MONTGOMERY COUNTY HISTORIC PRESERVATION COMMISSION
STAFF REPORT

Address:	101 Elm Avenue, Takoma Park	Meeting Date:	2/25/2026
Resource:	Contributing Resource Takoma Park Historic District	Report Date:	2/18/2026
Applicant:	Jared Hughes Morgan Malone (Agent)	Public Notice:	2/11/2026
Review:	HAWP	Tax Credit:	No
Permit Number:	1144999	Staff:	Devon Murtha
PROPOSAL:	Solar panel installation

The applicant proposes to install thirty (33) solar panels in three (3) arrays on the main roof of the subject property. The Canadian Solar TOPHiKu6 series panels will be mounted to the asphalt shingle roof. The load center and disconnect switch will be installed on the northwest corner of the house.

Figure 5: Solar panel plan approved in 2023 (left) and current proposal (right).

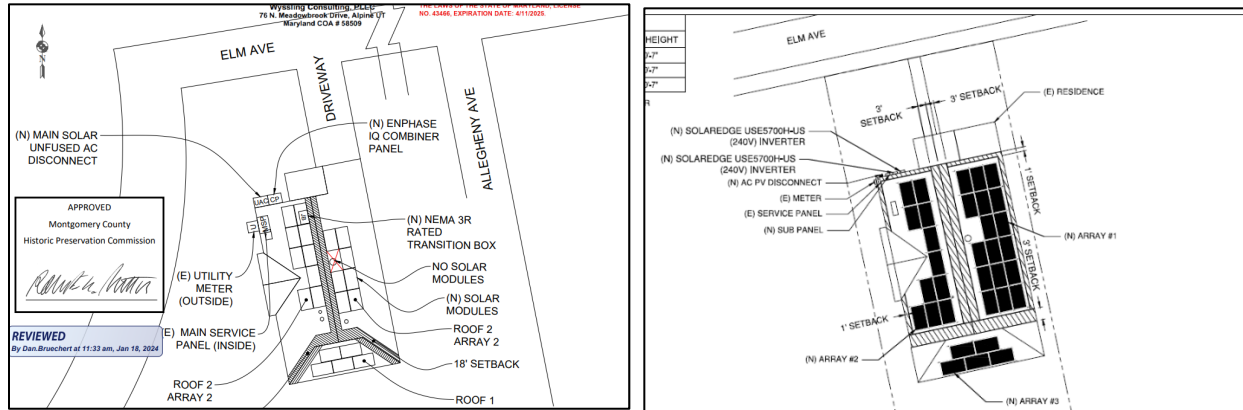
Staff generally supports the installation of the proposed solar panels and recommends approval. The HPC approved a proposal for solar panel installation on the subject property at the December 20, 2023 HPC meeting, but the project was never completed.¹ The new proposal utilizes the same roof planes as the previous proposal, but with additional panels (*Figure 5*).

Figure 9: Aerial view showing the subject property annotated with a yellow star, and nearby houses with solar panels visible from the right-of-way circled in red.

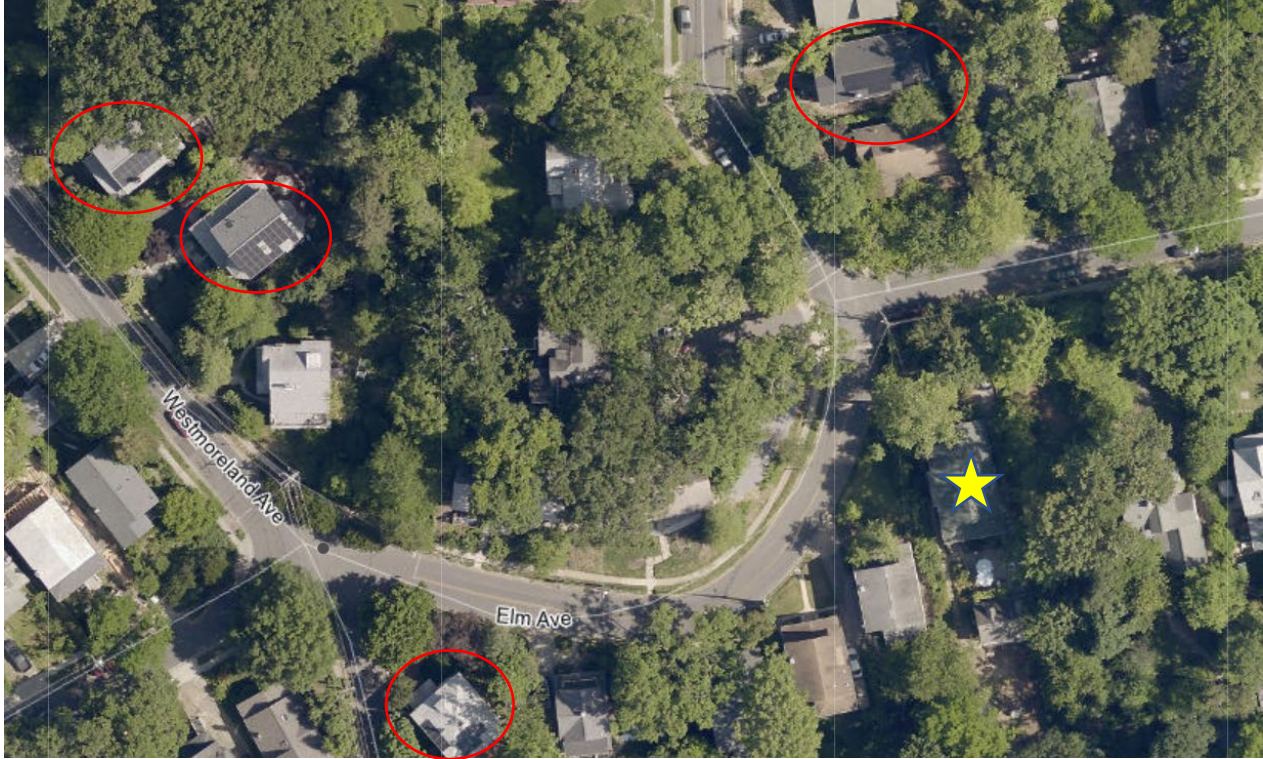
Additionally, photovoltaic systems are already an established element of the district; the HPC has approved the installation of solar panels in locations visible from the right-of-way on similar resources. In 2022, the HPC approved panels on the side of an Outstanding Resource at 28 Pine Avenue on a Contributing Resource at 49 Elm Avenue.² Both houses are less than a block away from the subject property (*Figure 9*).
